Rezoning Transportation Analysis

Petition Number: 2020-145

General Location Identifier: Tax ID: 22313218

Date	Description
11-30-20	First Review (LJ)

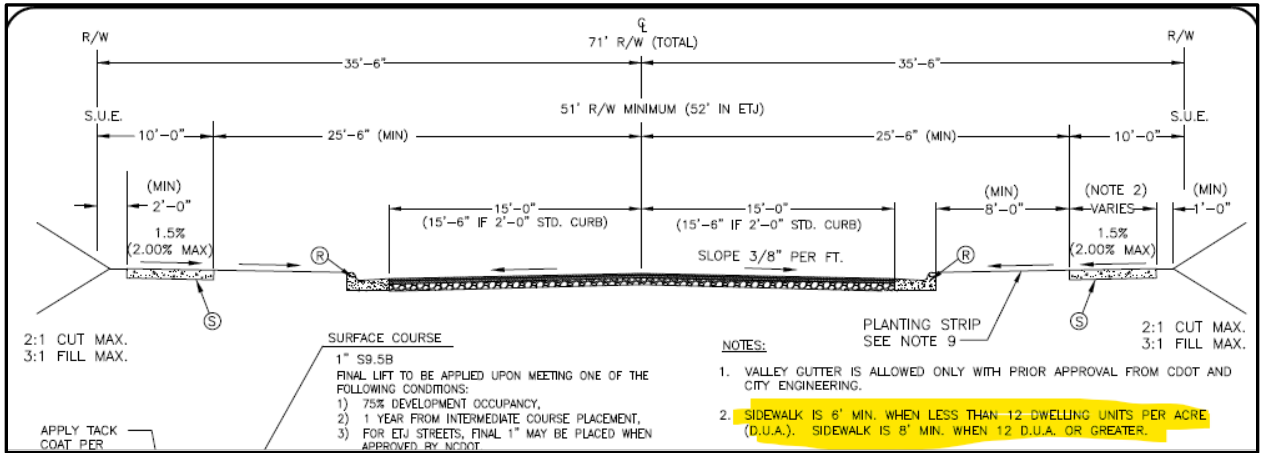
- Revise site plan and conditional note(s) to commit to dedicating 71' right-of-way for the Public Streets 'A' and 'B' per Chapter 20 and CLDSM, U-03A.19. The site plan shall label and dimension the right-of-way from road centerline.
- The Petitioner shall coordinate with NCDOT to obtain the required right-of-way width along Marvin Road and Johnston Road. Revise site plan and conditional note(s) to dedicate right-of-way from each road centerline.
- Revise site plans and conditional notes to commit to constructing an 8-foot planting strip, and 8-foot sidewalk along Public Roads 'A', 'B', and 'C' per Chapter 20, as the proposed dwelling units exceed 12

Reference (CLDSM standard detail U-03A) for street typical.

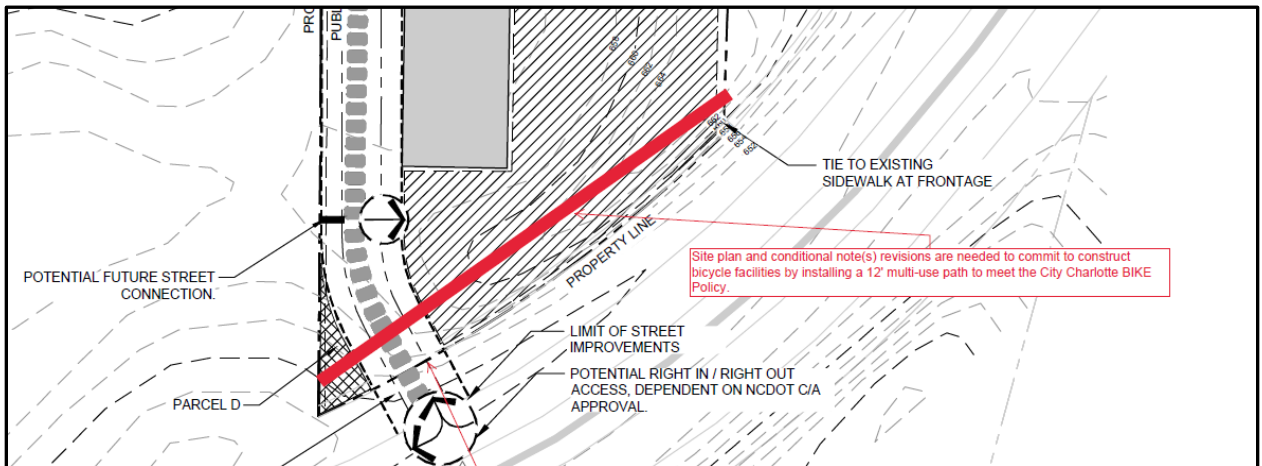
per acre. The wider sidewalk also meets the Charlotte WALKS Policy. The site plan shall label and dimension both items from the back of curb and gutter to the road centerline.

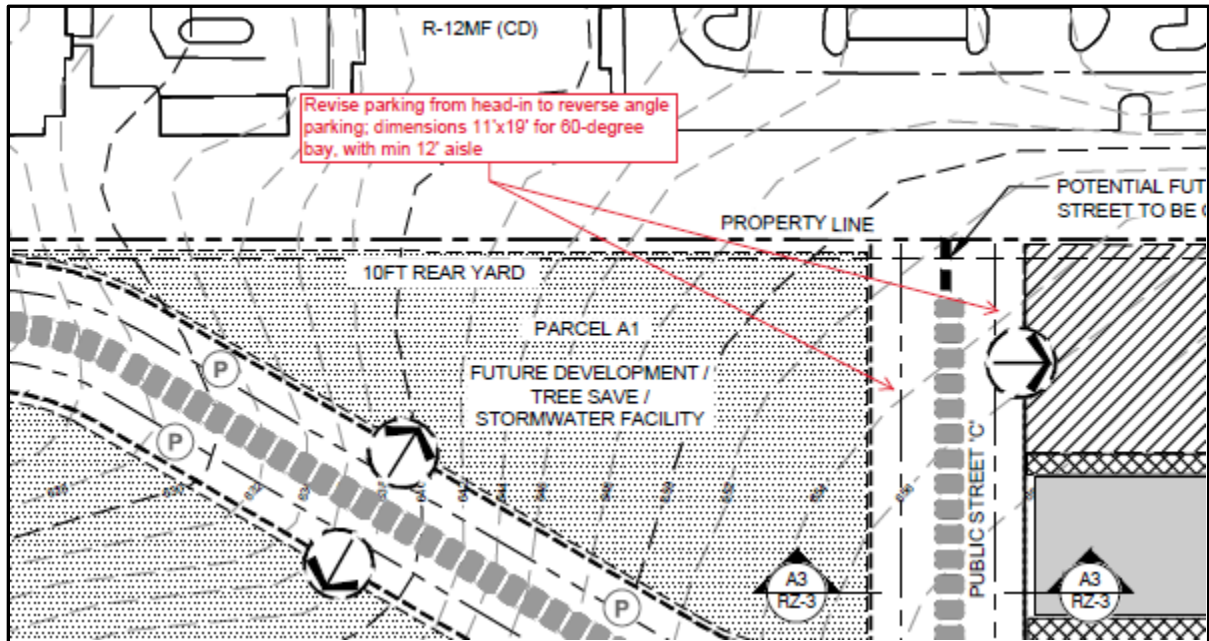
7. Revise the site plan and conditional note(s) to provide reverse-angle parking instead of head-in angle parking on public street 'C'. Dimensions shall be 11' x 19' (tangential to street, perpendicular to street) for a 60-degree bay, with a minimum 12' aisle width. The 11' x 19' dimension shall be scaled accordingly.
